Item Name: Quick Release Basket Mounting Spacepod™ & Squirrel Cheek Fits LH or RH

DART SERVICE INSTRUCTION

TO AMEND INSTALLATION INSTRUCTIONS D350-607-3 Rev.D,
INSTALLATION INSTRUCTIONS D350-607-4 Rev. C AND
INSTRUCTIONS FOR CONTINUED AIRWORTHINESS ICA-D350-607 REV. 6
REF TCCA STC: SH94-14
REF FAA STC: SR00213NY
REF EASA STC: EASA.10016996
REF BRAZILIAN STC: 2007S03-03/-04/-05/-06

A	NEW ISSUE	AJS	14.05.16
REV.	DESCRIPTION	BY	DATE
DESIGN	AJS	DART AEROSPACE LTD HAWKESBURY, ONTARIO, CANADA	
DRAWN	AJS		
CHECKED		DRAWING NO.	REV. A
MFG. APPR.	N/A	DSI 9699	SHEET 1 OF 2
APPROVED		TITLE	SCALE
DE APPR.		LUG REPLACEMENT	NTS
DATE	14.05.16	COPYRIGHT © 2014 BY DART AEROSPACE LTD THIS DOCUMENT IS PRIVATE AND CONFIDENTIAL AND IS SUPPLIED ON THE EXPRESS CONDITION THAT IT IS NOT TO BE USED FOR ANY PURPOSE OR COPIED OR COMMUNICATED TO ANY OTHER PERSON WITHOUT WRITTEN PERMISSION FROM DART AEROSPACE LTD.

FIGURE 1: INSTALLATION OF D4775-041 FWD STRUT

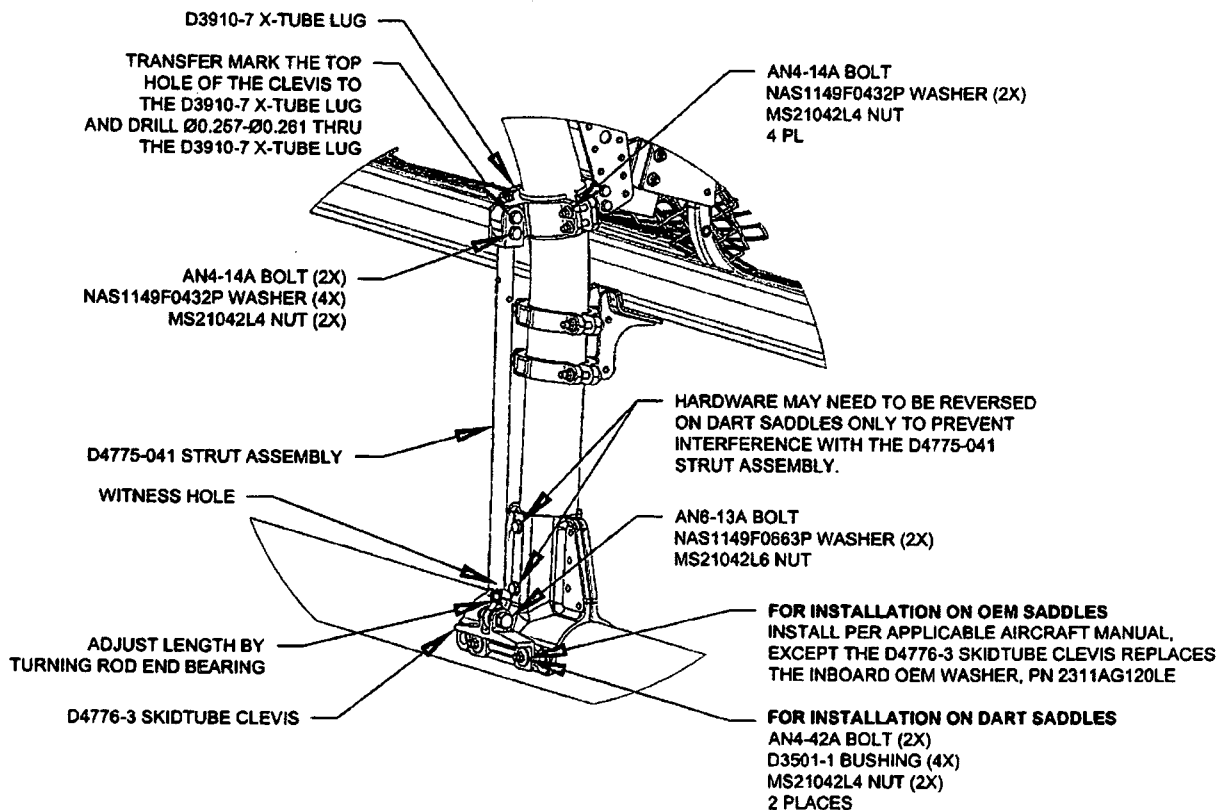
- 3.1 Substitute the Forward Lower D3910-5 X-Tube Lug with the D3910-7 X-Tube Lug as shown in Figure 1.
- 3.2 Install the forward D4775-041 Strut Assembly. Transfer mark from the upper hole on the clevis of the D4775-041 Strut Assembly to the D3910-7 X-tube Lug and drill thru the lug $\varnothing 0.257$ - $\varnothing 0.261$ as shown in Figure 1. Touch up chemical conversion coating per MIL-DTL-5541. Check the witness holes located at the bottom end of the D4775-041 Strut Assemblies to ensure that the thread from the rod end extends past the witness hole.
Torque MS21042L4/-4 nuts to 50-70 in-lbs (5.7-7.9 N-m). Torque MS21042L6/-6 nuts to 160-190 in-lbs (18.1-21.5 N-m).
- 3.3 Complete the installation in accordance with Installation Instructions D350-607-3 Rev. D or D350-607-4 Rev. C.
